ADDENDUM TO THE CONTRACT DOCUMENTS

ADDENDUM No.: 3

DATE : 9/4/15

PROJECT: New Town Hall
Construction Project
26 Court Street
Plymouth, MA

FIRST FLOOR OUTLET/DIFFUSER PLAN

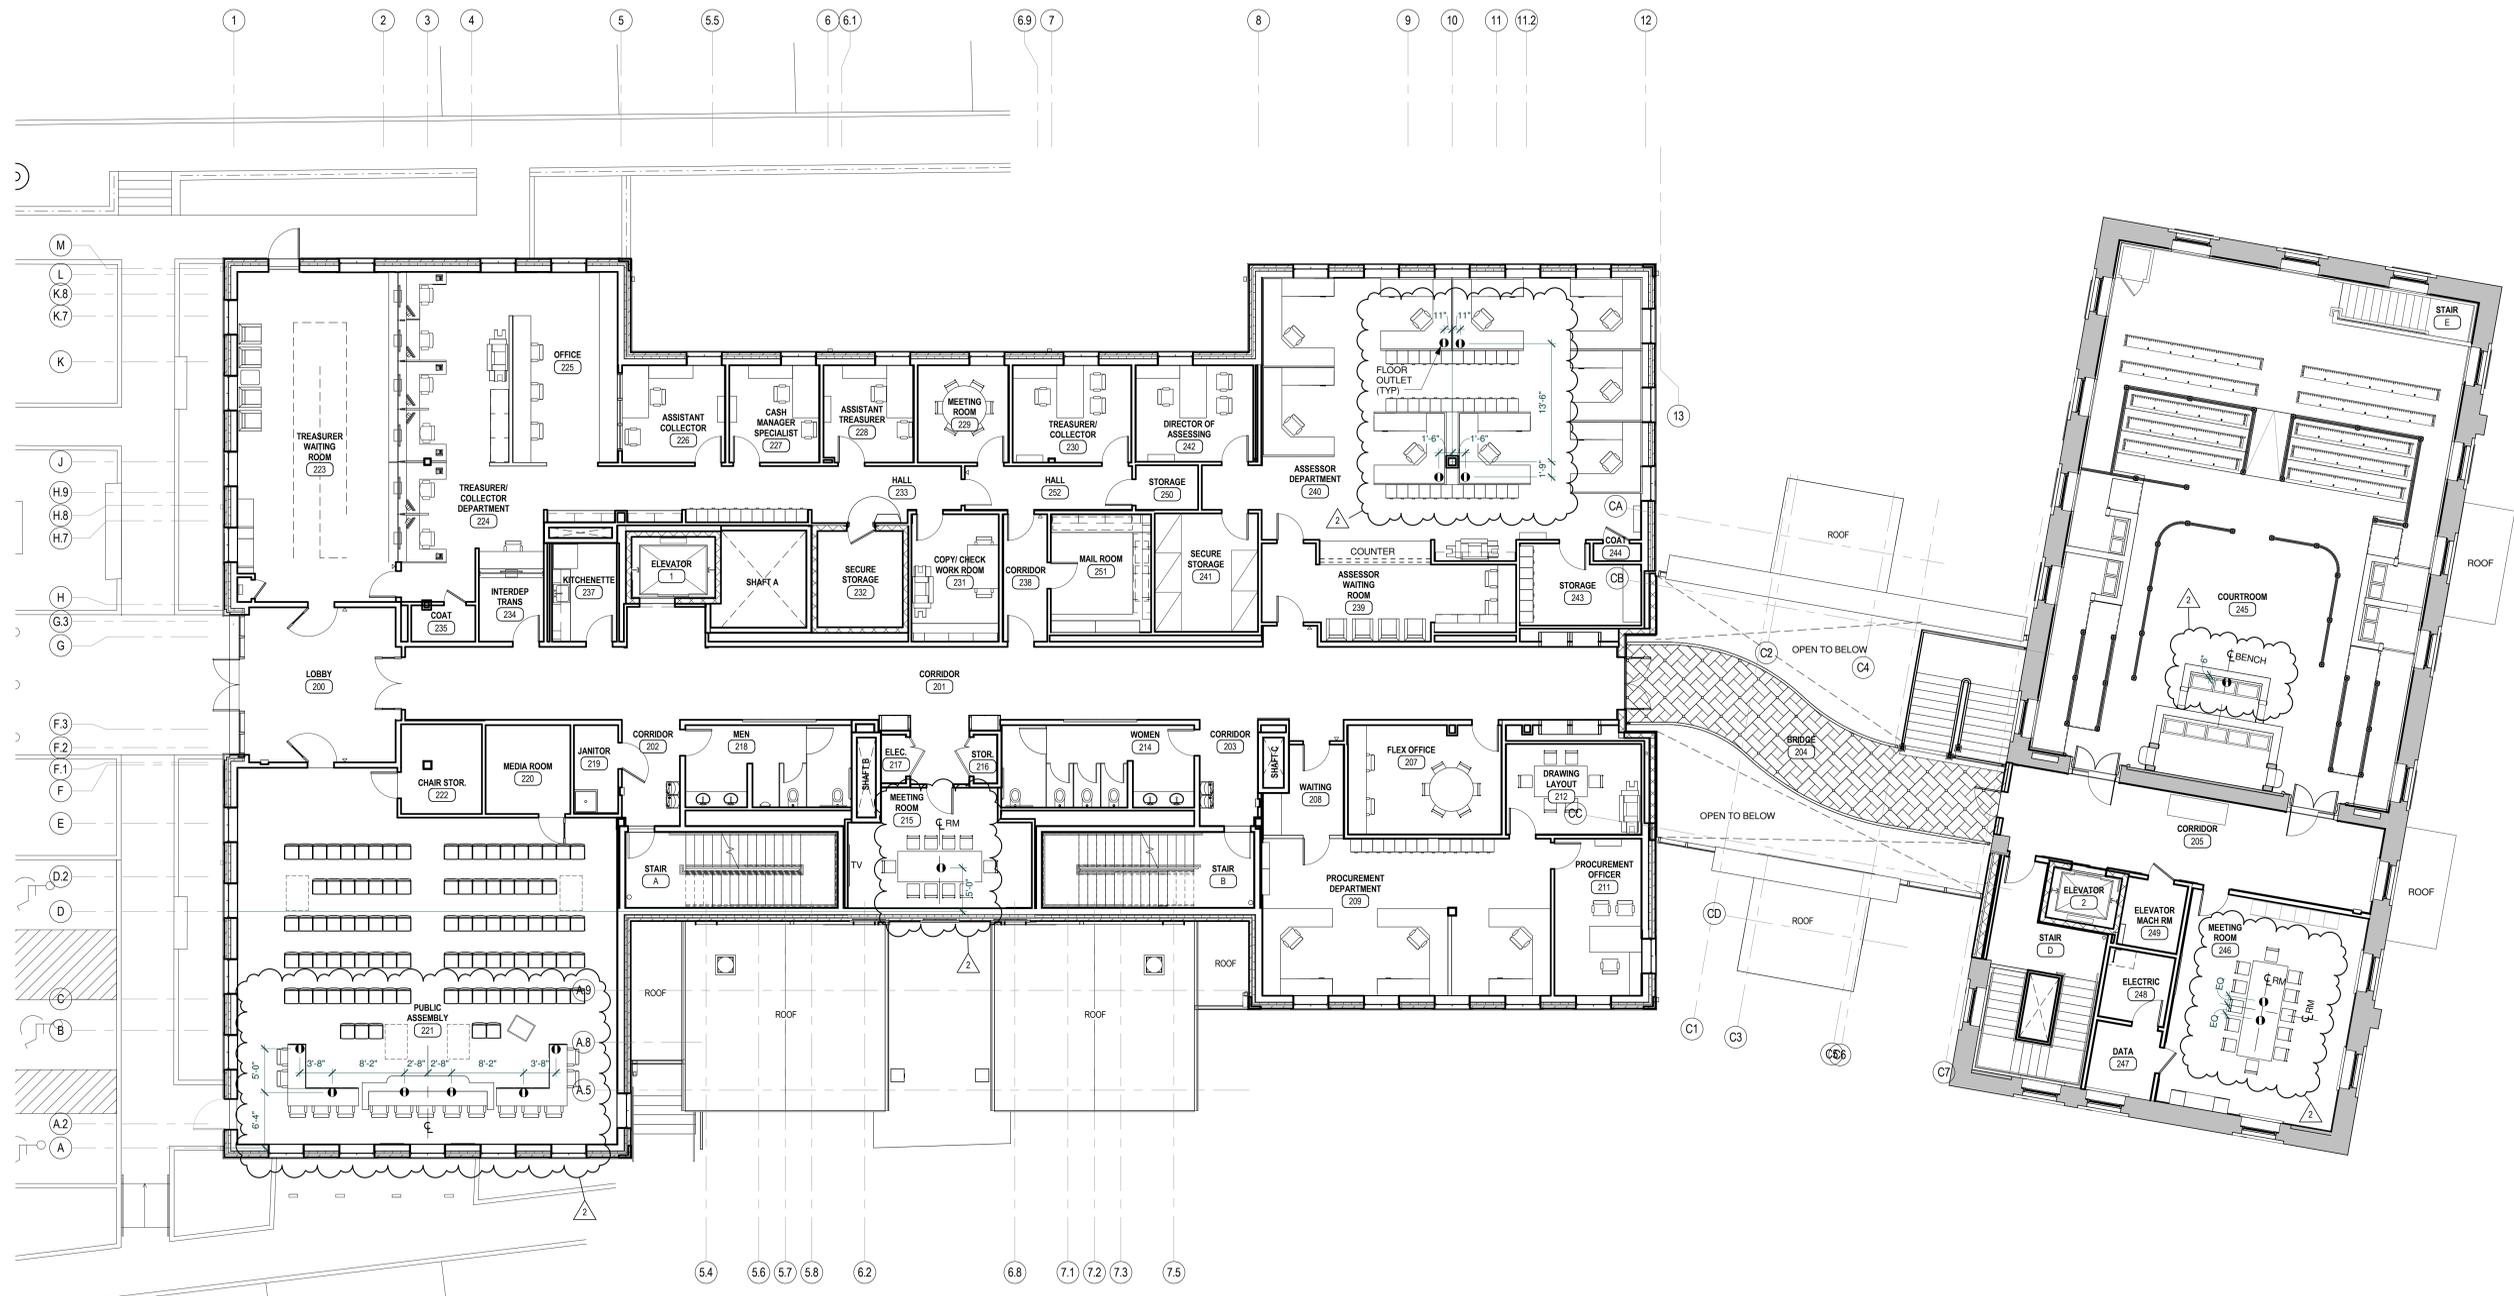
- SKA-004 First Floor Outlet/Diffuser Plan, dated 9/2/15.
- SKA-005 Second Floor Outlet Plan, dated 9/2/15.
- SKA-006 Third Floor Outlet Plan, dated 9/2/15.
- SKA-007 Fourth Floor Outlet Plan, dated 9/2/15.

RETURN DUCT REVISION

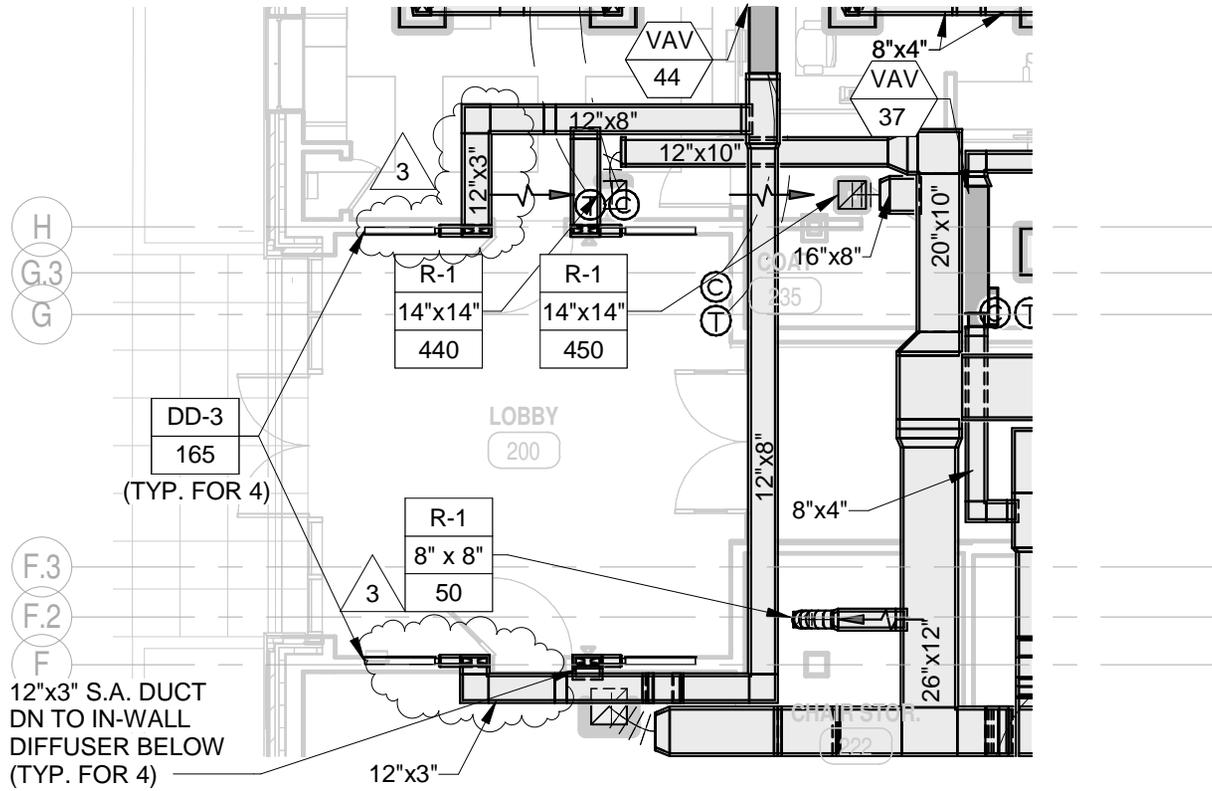
- SKM-007 Return Duct Revision, dated 9/2/15.
- SKM-008 Supply Duct Revision, dated 9/2/15.
- SKM-009 Cabinet U.H. CLG-Type Correction, dated 9/2/15.
- SKM-010 Generator Fuel Oil Controls Addition, dated 9/2/15.

GENERATOR FUEL OIL CONTROLS ADDITION

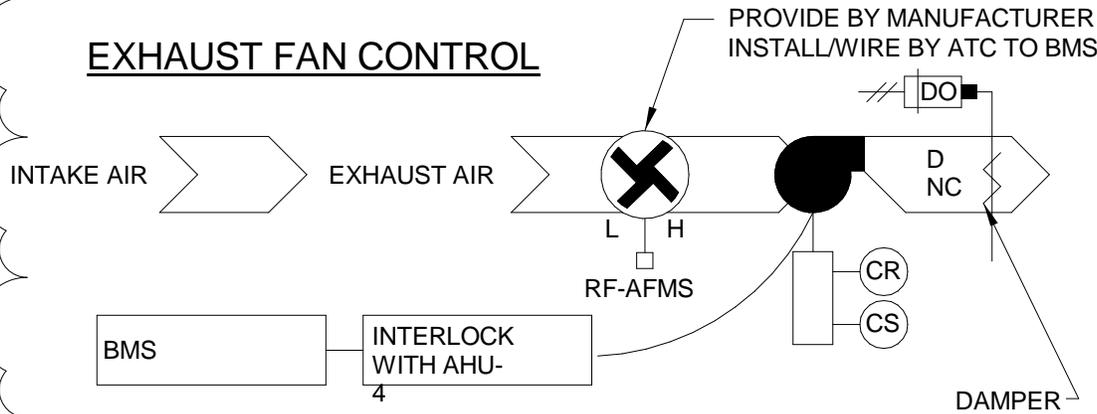
M401	<ol style="list-style-type: none"> 1. Generator Fuel Oil Controls Addition, Refer to Sketch SKM-010. 2. Misc. BMS Control Points Revision, Refer to Sketch, SKM-022.
M402	Special Archives Unit Text Revision, Refer to Sketch, SKM-023.
M403	Exhaust Fan Type III Control Addition, Refer to Sketch SKM-011.
M404	<ol style="list-style-type: none"> 1. Weather Station Addition & Clarification, Refer to Sketch SKM-010. 2. AHU-4 Controls Text Revision, Refer to Sketch SKM-024. 3. AHU-4 Controls Diagram Revision, Refer to Sketch SKM-025. 4. AHU-4 VSD & Controller Revision, Refer to Sketch SKM-026. 5. AHU-4 BMS Points Revision, Refer to Sketch SKM-027.

EXH. FAN TYPE III CONTROLS ADDITION

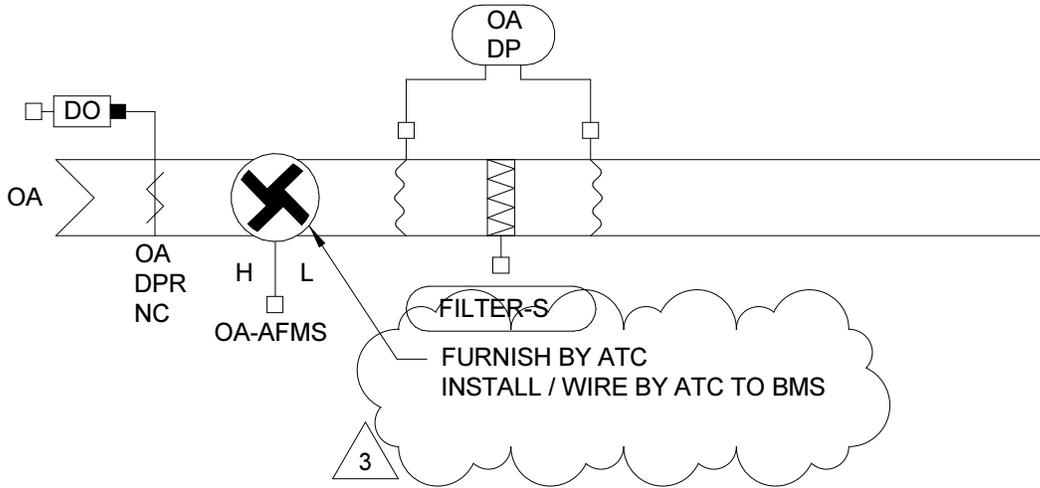
- SKM-011 Exh. Fan Type III Controls Addition, dated 9/2/15.
- SKM-012 Weather Station Addition & Clarification, dated 9/2/15.
- SKM-013 AHU-1 Location Revision, dated 9/2/15.

3. TYPE 3: EXHAUST FAN SHALL BE INTERLOCKED WITH NOTED AIR HANDLING UNIT TO RUN WHEN AIR HANDLING UNIT RUNS, AND DE-ENERGIZE WHEN AIR HANDLING UNIT IS OFF. EXHAUST FAN SHALL MODULATED AS REQUIRED TO MATCH THE OUTSIDE AIRFLOW UTILIZING BOTH AIRFLOW STATIONS. DURING ECONOMIZER MODE DETERMINED THROUGH DDC SYSTEM, THE EXHAUST FAN SHALL MODULATE TO 100% AIRFLOW & MATCH THE SUPPLY AIRFLOW UTILIZING BOTH AIRFLOW STATIONS.

AHU-1 LOCATION REVISION

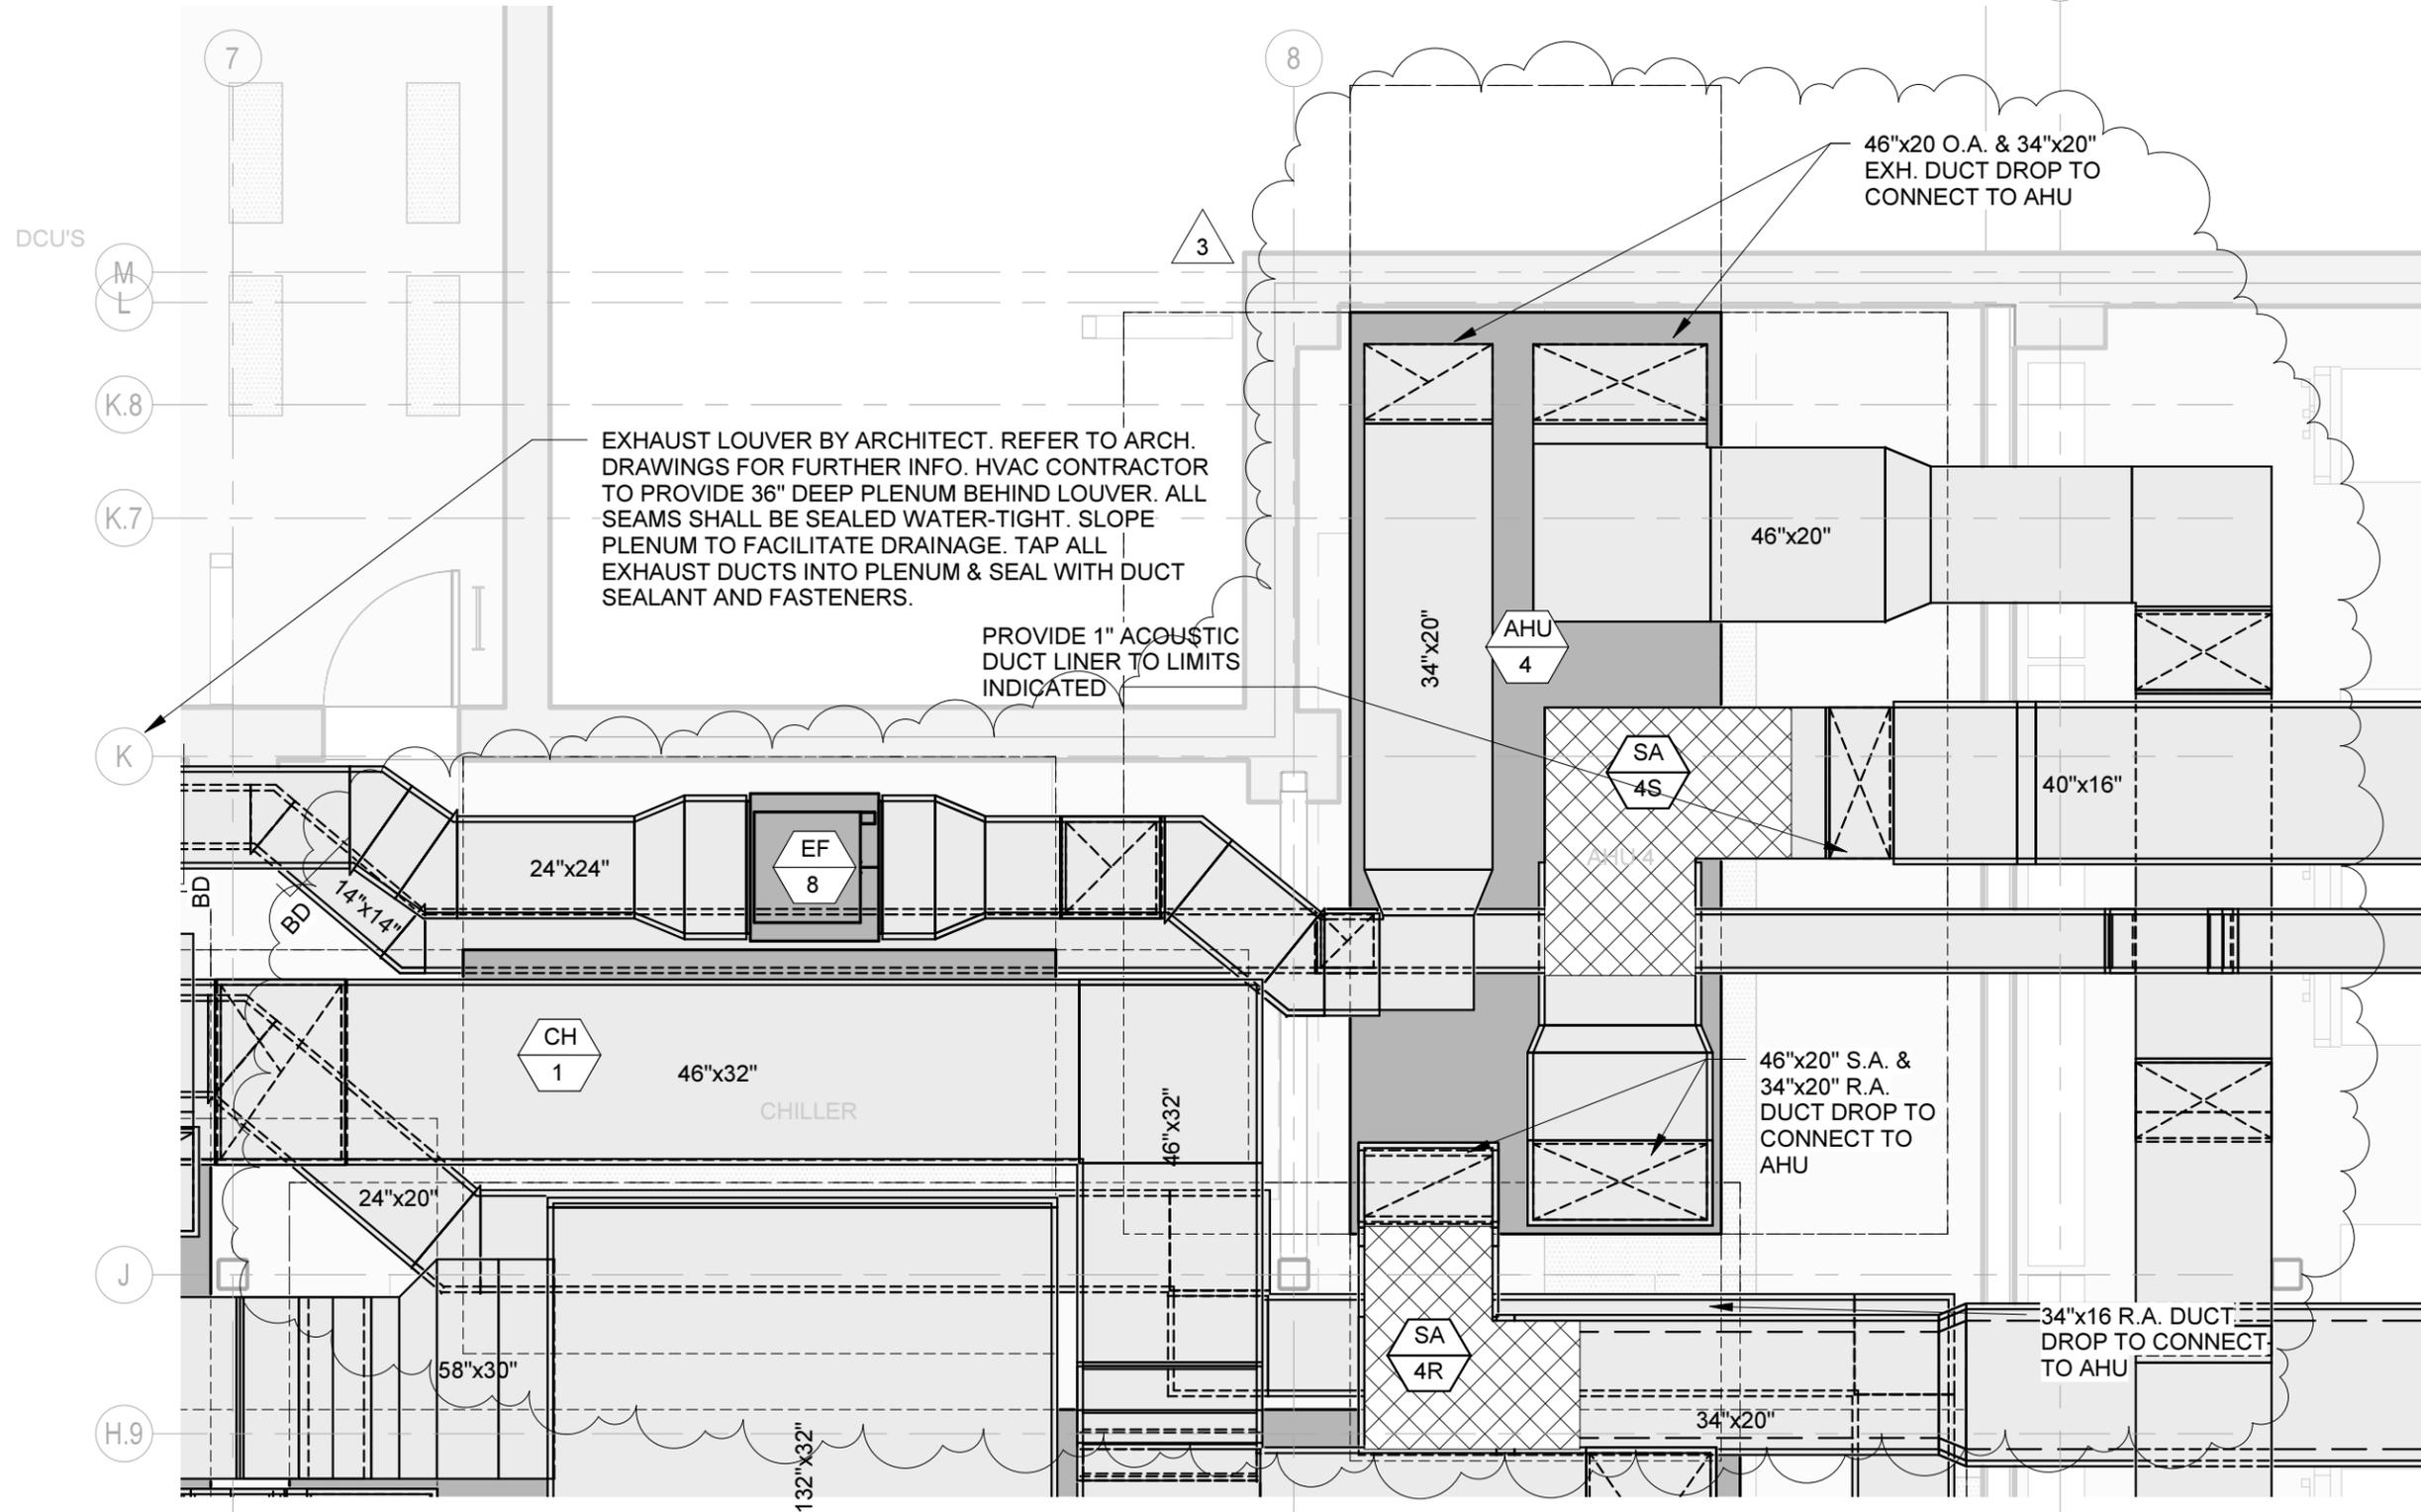
Drawing No.:	Description:
Mechanical	
General Note:	Drawing Notes for the following Drawings M101, M102, M103, M105, M106, M201, M202, M203, M204, M205, M206: ADD Note, "Within the existing courthouse the HVAC Contractor shall disconnect and make safe all existing HVAC related equipment, devices, and components such as existing boiler, condensate receivers, radiators, fans, pumps, piping, control wiring, pneumatic tubing, pneumatic compressors, thermostats, unit heaters, etc. The General Contractor shall remove and dispose of all equipment, devices, and components in a legal manner. HVAC Contractor to coordinate with General Contractor and field verify all necessary disconnects for a complete demolition/removal of all HVAC related appurtenances."
M102	1. Return Duct Revision, Refer to Sketch SKM-007.
M103	Supply Duct Revision, Refer to Sketch SKM-008.
M106	<ol style="list-style-type: none"> AHU-1 Location Revision, Refer to Sketch SKM-013. AHU-4 Duct Connection Revisions, Refer to Sketch SKM-014.
